Edits and Additions to the Proposed Plan in Response to Public Comments

Downtown Station Area SP

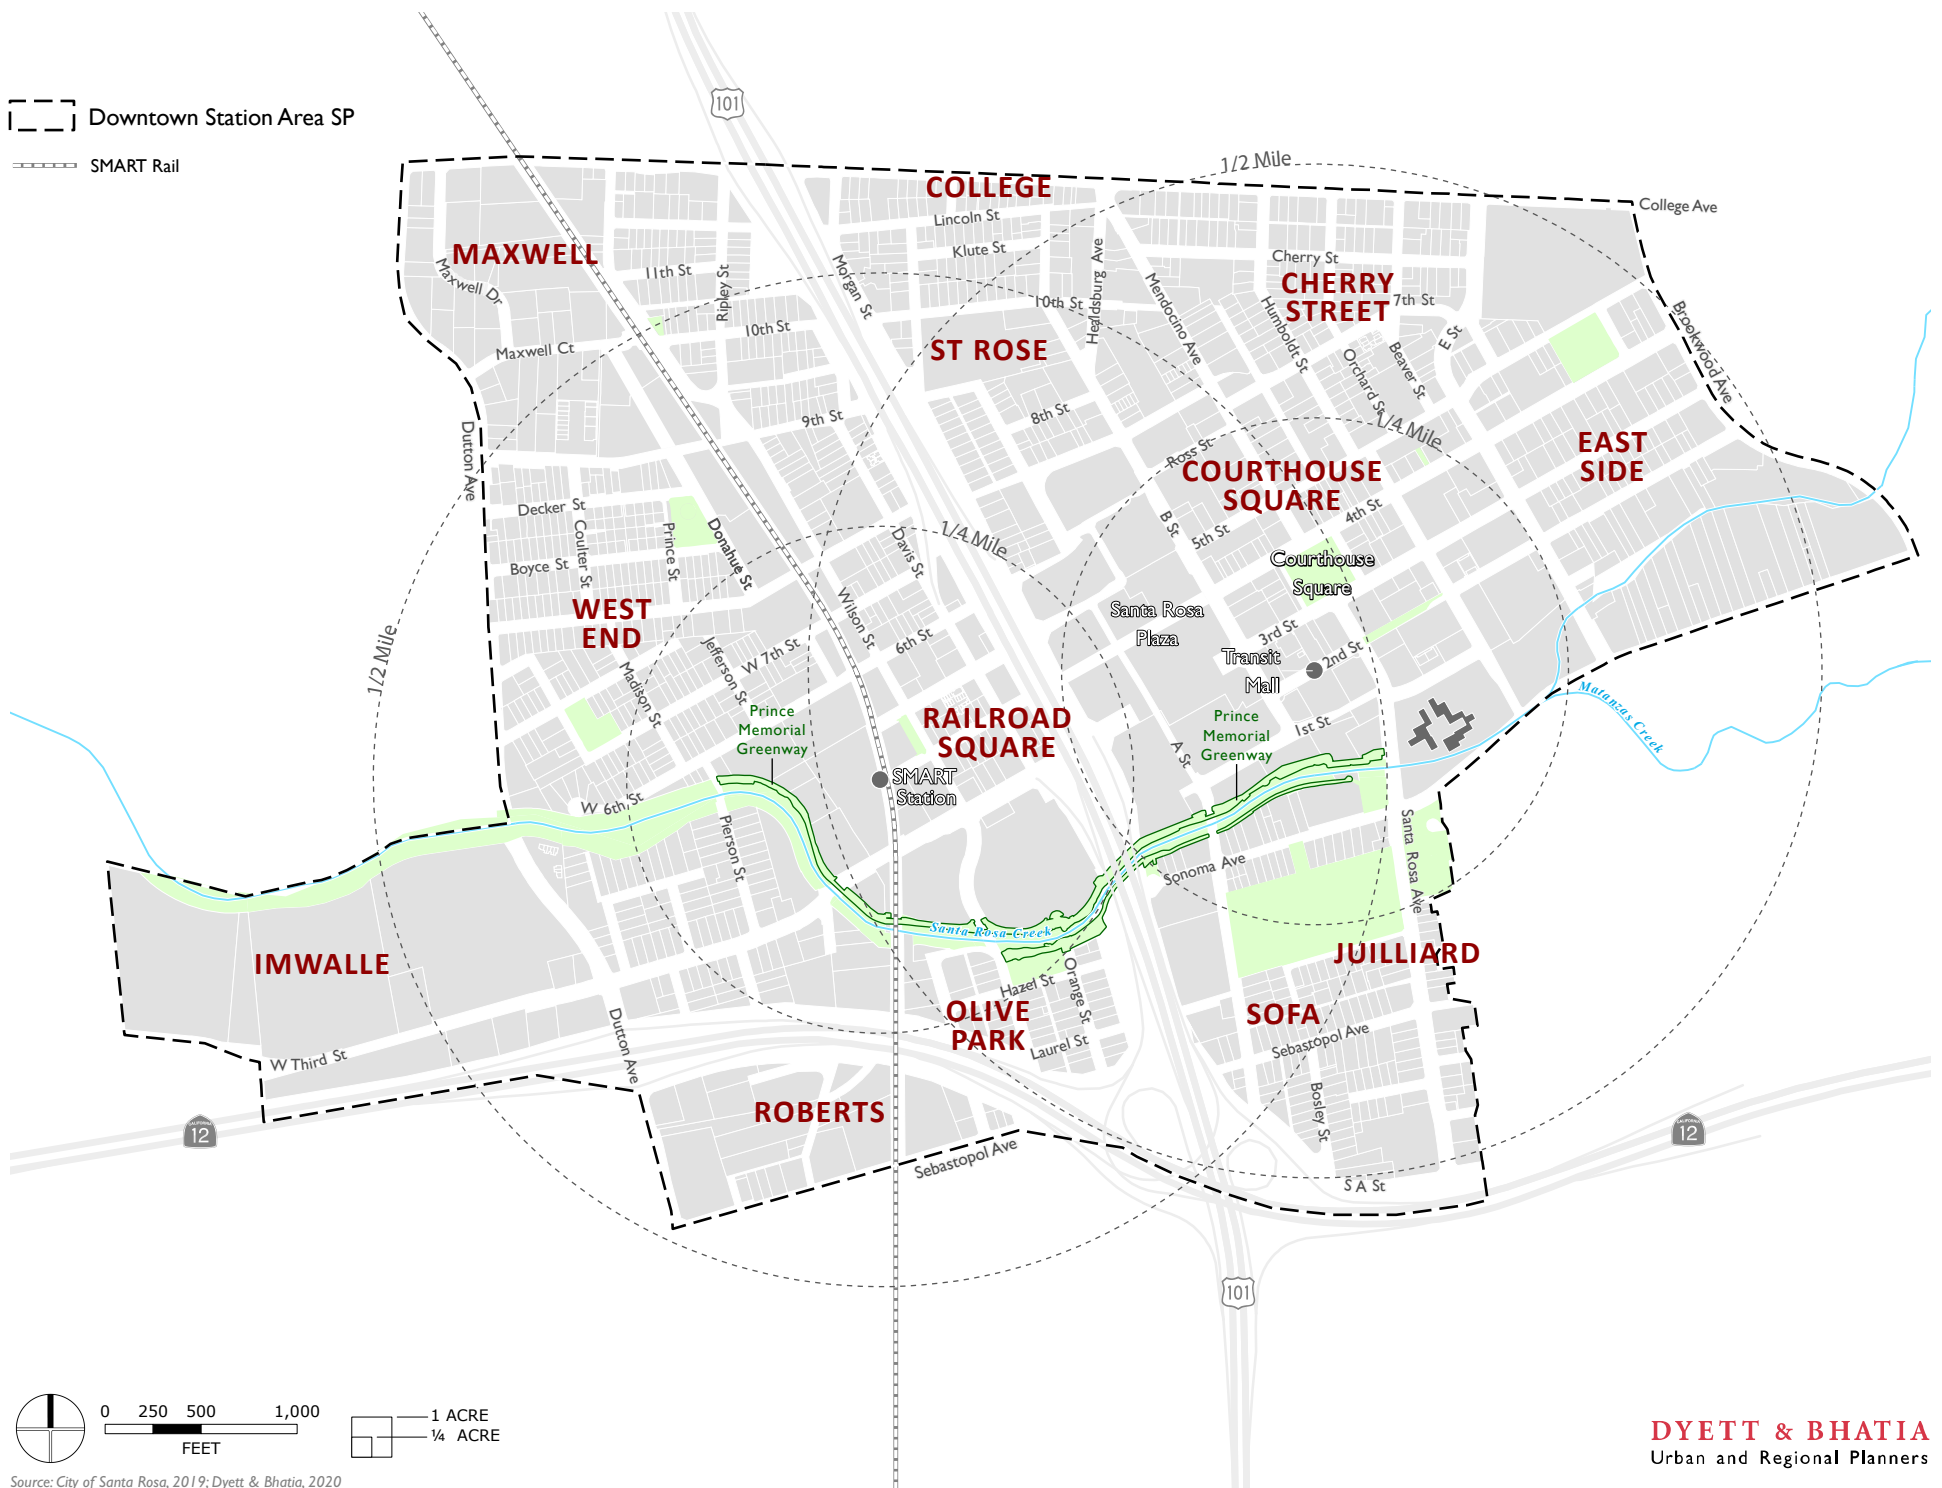
Introduction	1-9; 3-10; 3-11; 5-15	Keep consistent: <u>Citywide</u> Creek Master Plan
Introduction	Map Intro-1	Delineate Prince Memorial Greenway on Map INTRO-1
Land Use	2-2	Change Vacant Land description on Page 2-2 to state the following: Several large sites account for a large portion of this vacant land, including the SMART site west of the Downtown Station between West Third and West Sixth Streets and several properties in the <u>western portion</u> of the Downtown Station Area around Imwalle Gardens.

LU-3: Land Use

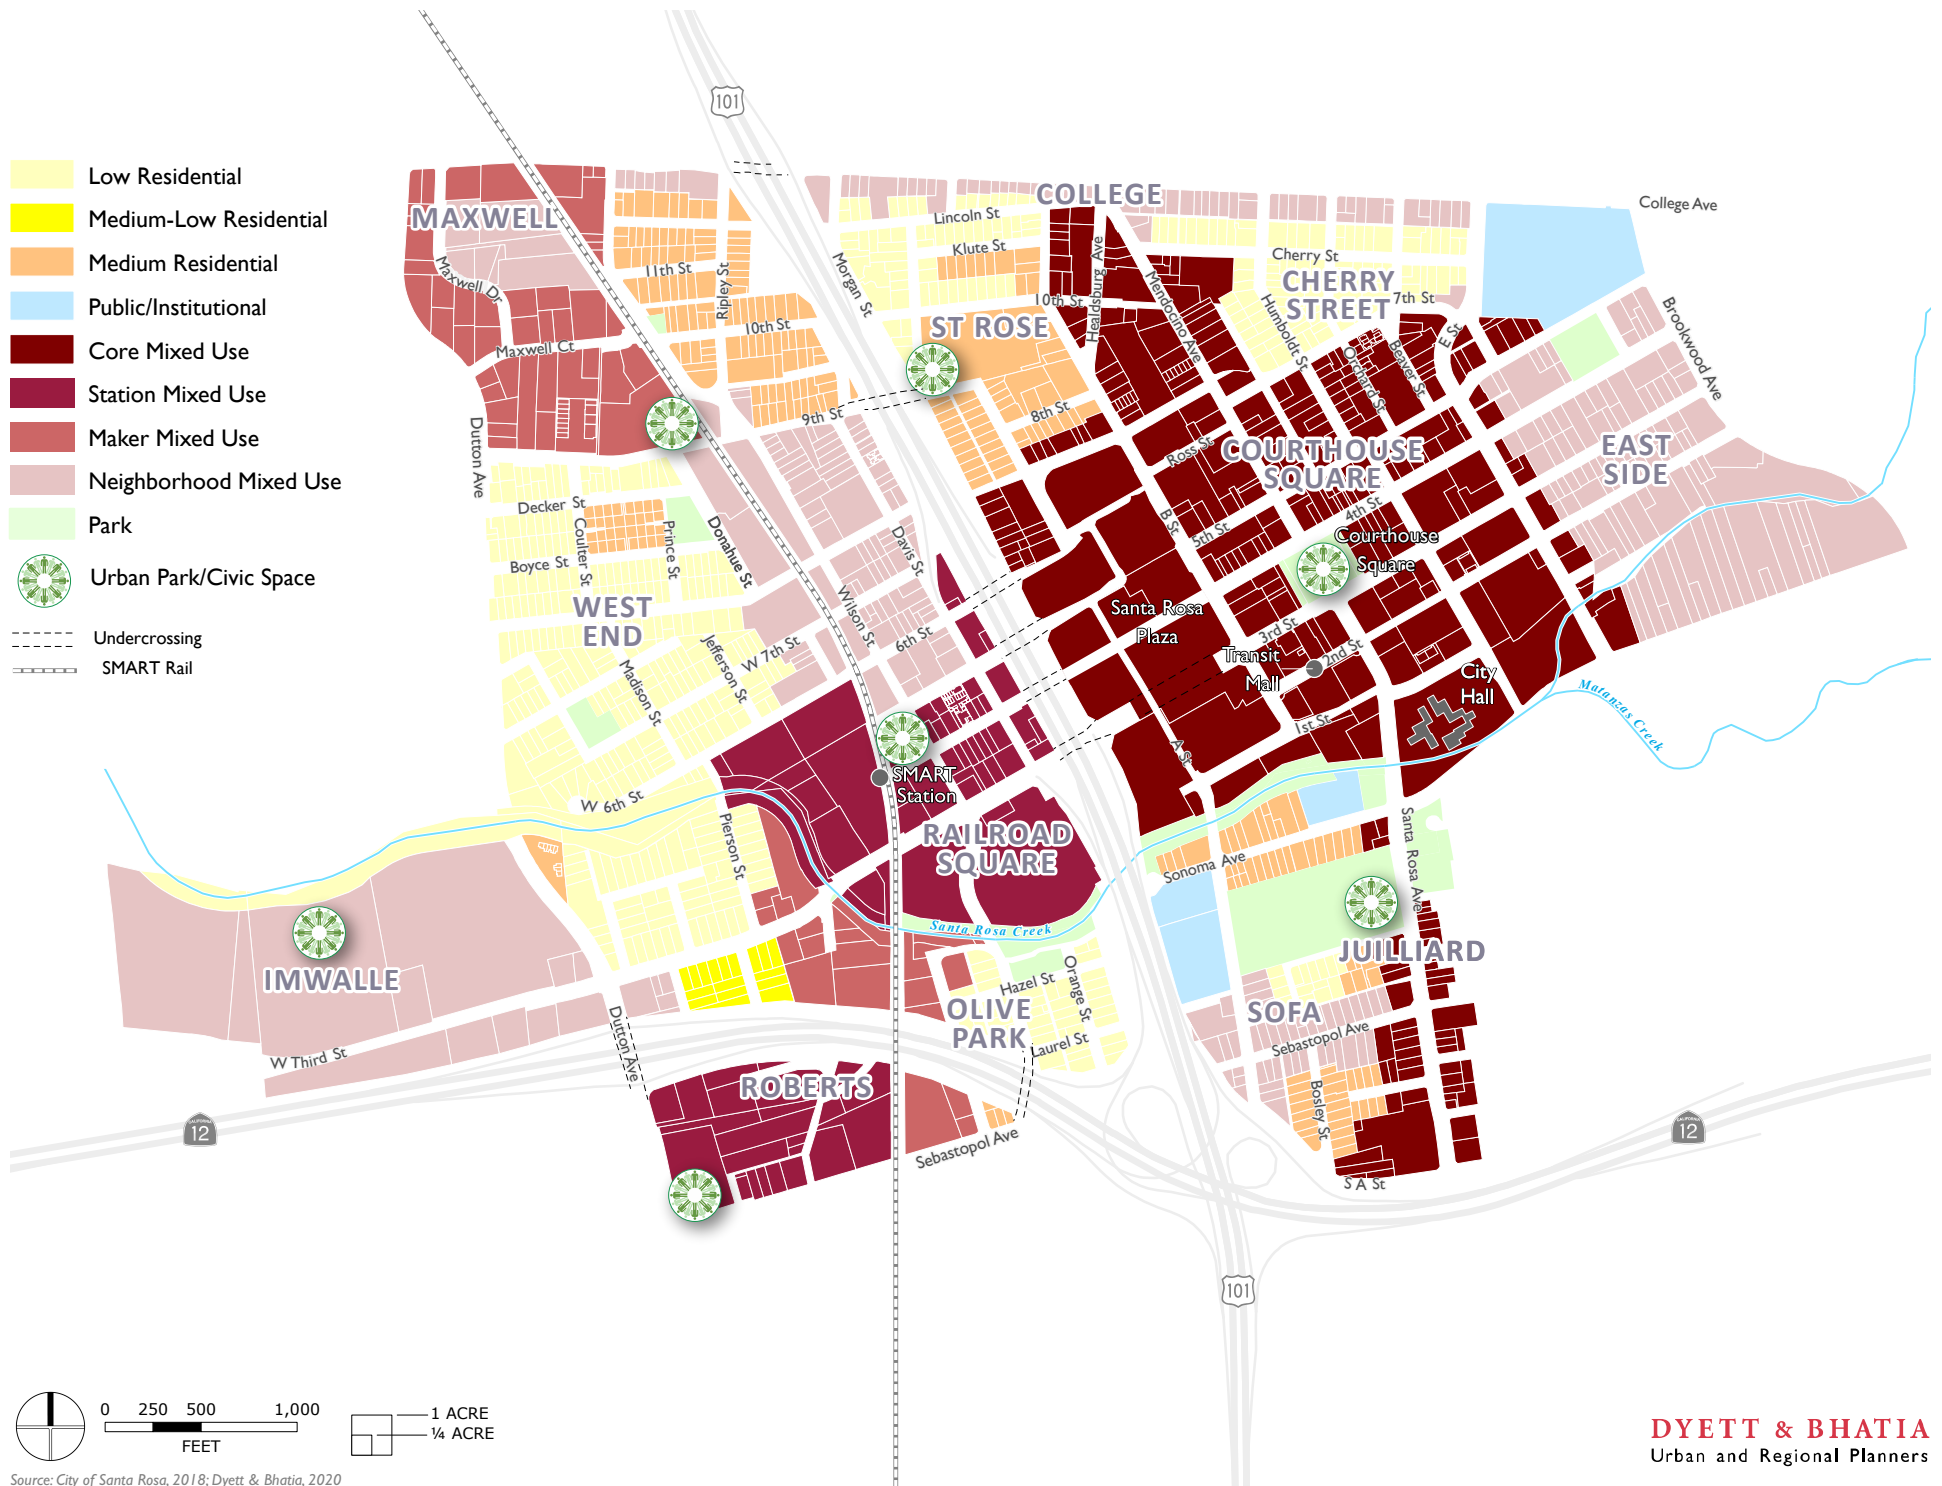
Land Use	2-17	Add Policy: Require new development within the Core Mixed Use, Station Mixed Use, Maker Mixed Use, and Neighborhood Mixed Use designations to achieve the mid-point or higher of the maximum FAR. Exceptions are allowed where parcel configuration, historic preservation or utility constraints make the mid-point impossible to achieve.
Land Use	2-17	LU-2.6: Require commercial uses that exceed 15,000 square feet to have a multi-storied format, rather than be spread out horizontally, and integrate other uses. Grocery stores are excepted from this requirement. Allow single-story development only if it can be shown to be complimentary and compatible with the vision and desired character for the area where it is proposed.
Land Use	2-19	Policy LU- 3.8- Replace "metro" chamber with "area" chamber of commerce groups
Land Use	Map Intro 1; Map LU-3	Remove "North Railroad Square" notation on map.

Land Use	Map LU-3, Map LU-5	Apply Neighborhood MU land use and max FAR of 2.0 for the properties on W. 3rd between Dutton and Decoe
Land Use	Map LU-3, Map LU-5, Map UDCS-1	Apply Core MU land use and max FAR of 4.0 for 526 Sonoma Avenue; add Neighborhood Transition to west-facing side of parcel
Land Use, Urban Design and Civic Spaces	Map LU-3, Map LU-5, Map UDCS-1	Apply Core MU land use and max FAR of 3.0 for two blocks on B Street north of Healdsburg Avenue up to Lincoln Ave. (Core Mixed Use - FAR 3). Add Neighborhood Transition to parcels fronting B Street.
Land Use	Map LU-5	Apply max FAR of 4.0 for one block on B Street between 7th Street and Healdsburg Avenue (Core Mixed Use - FAR 4).
Mobility	3-2	Replace "Vehicle Miles Traveled" header with "Performance Metrics"
Mobility	3-4	Edit Policy MOB-1.1 to clarify as follows: Maintain a roadway classification system as illustrated in Figure MOB-1, with the following segments as Boulevards designed to accommodate transit, bicycles, and pedestrian facilities together with vehicle traffic: * <u>Santa Rosa Avenue from Sonoma Avenue to South A Street</u> * <u>E Street from Sonoma Avenue to College Avenue</u>

MOB-4: Planned Pedestrian Improvements

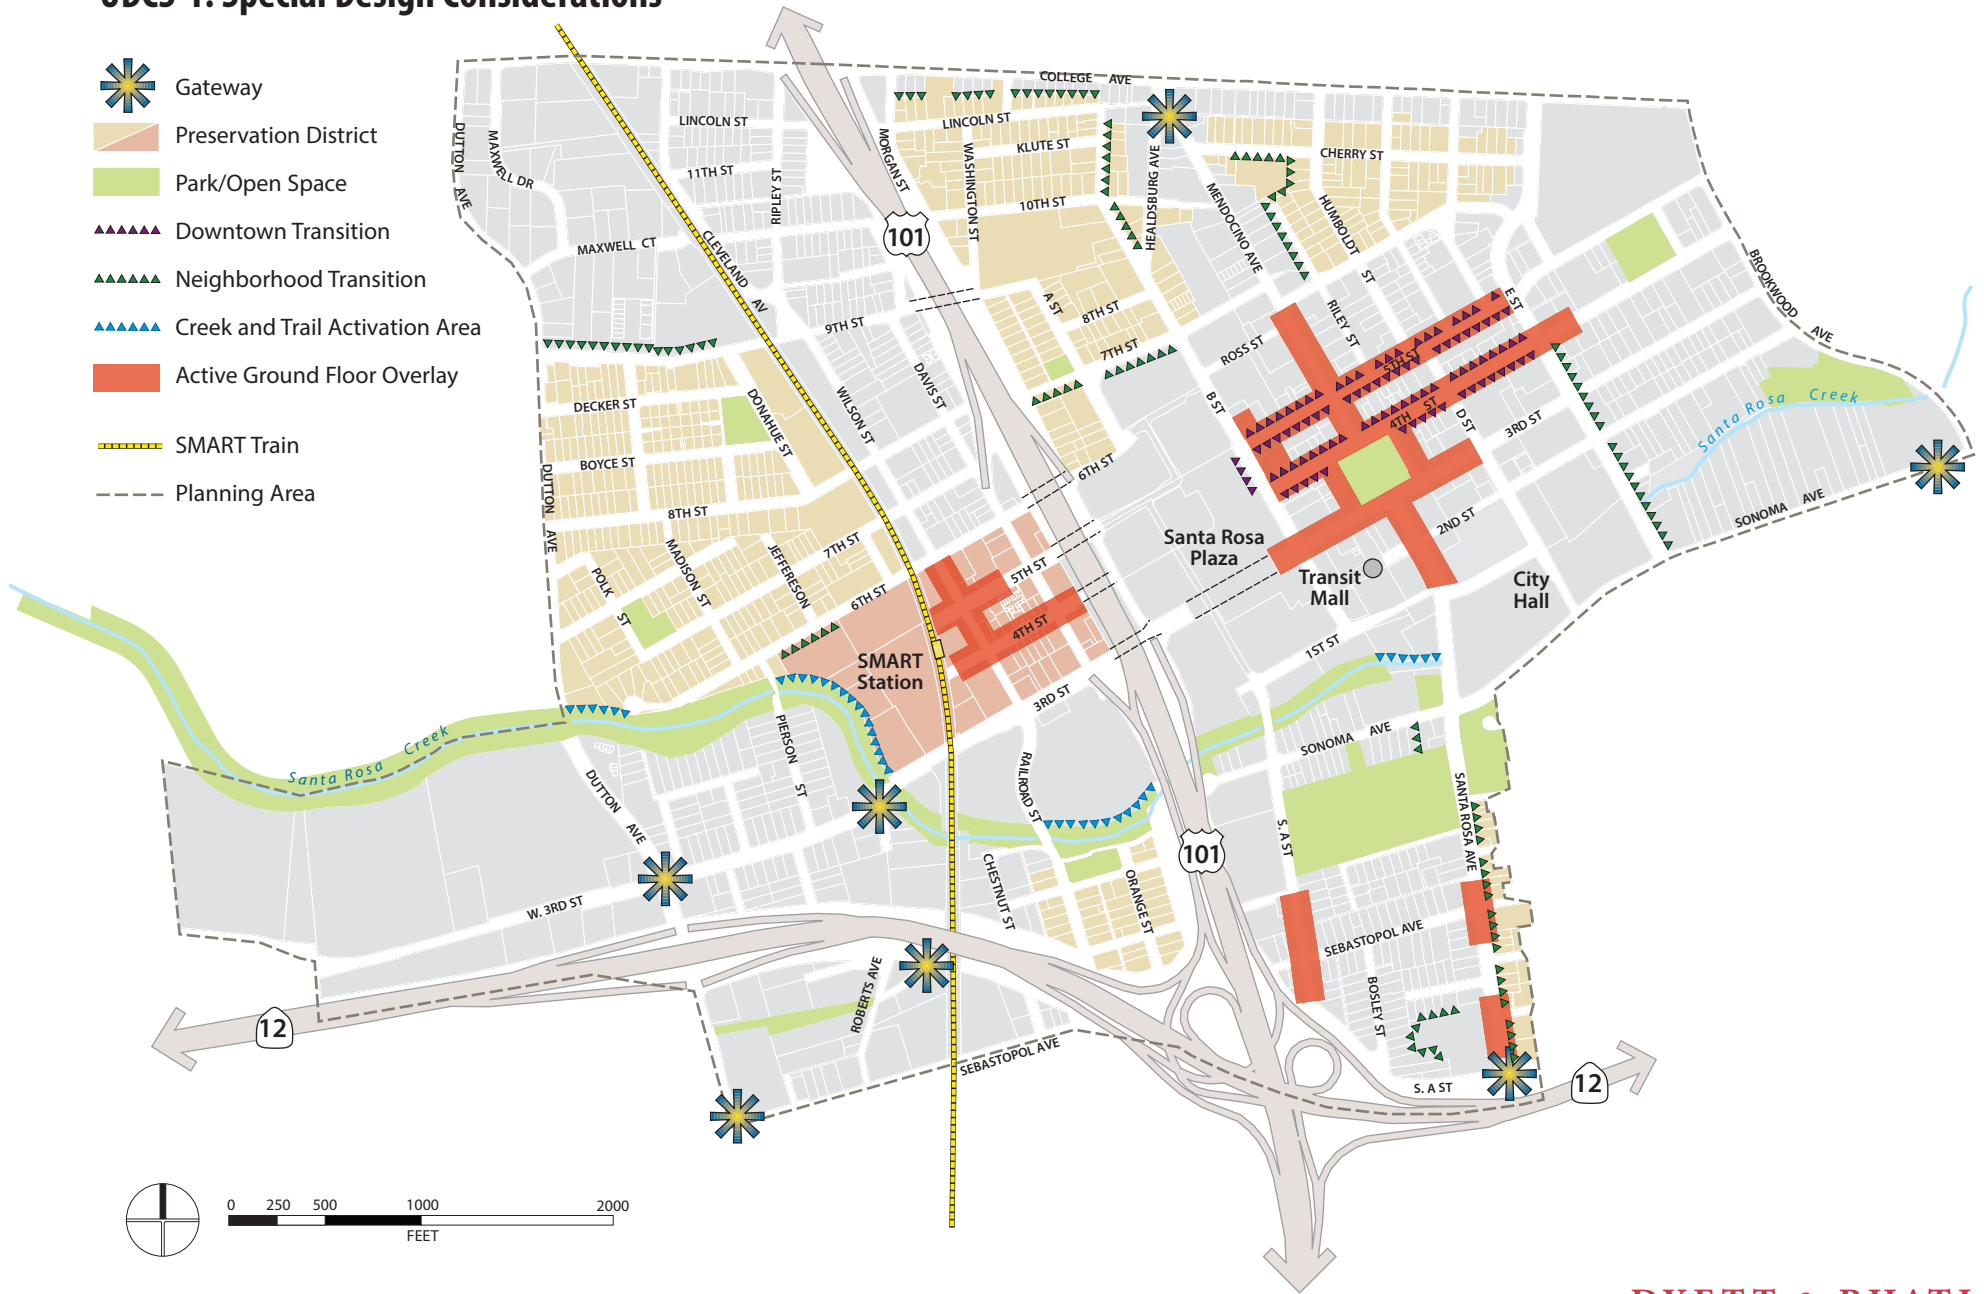
Mobility	3-24	Correction to MOB-6.4: Prohibit new stand-alone surface parking lots and encourage the <u>conversion</u> of existing parking lots to increase housing density.
Mobility	Map MOB-3; Map MOB-4	Show Class II bicycle facility on Map MOB-3 and MOB-4 between West Third Street and West Sixth Street through the SMART property
Mobility	Map MOB-3	Add planned Class II Bike Path to Brookwood Ave from 2nd Street to College Ave
Mobility	Map MOB-3	Add Trail Access Points at Imwalle, north of creek at Railroad Street, clarification that downstream of Pierson is a gravel path, and that daylighting can occur at both Matanzas and Santa Rosa Creeks
Mobility	Map MOB-4	Add a pedestrian improvements icon to Map MOB-4 at Sonoma and Santa Rosa Avenue (as envisioned in bike ped master plan)
Mobility	Map MOB-4	Show bicycle/pedestrian through-connection from Santa Rosa Creek to SMART station at 4th Street
Urban Design and Civic Spaces	4-3	DS-1, Revise bullet four to insert a comma between "on-site" and "or" so that a curbside parklet is not required to be a minimum of 600 feet.
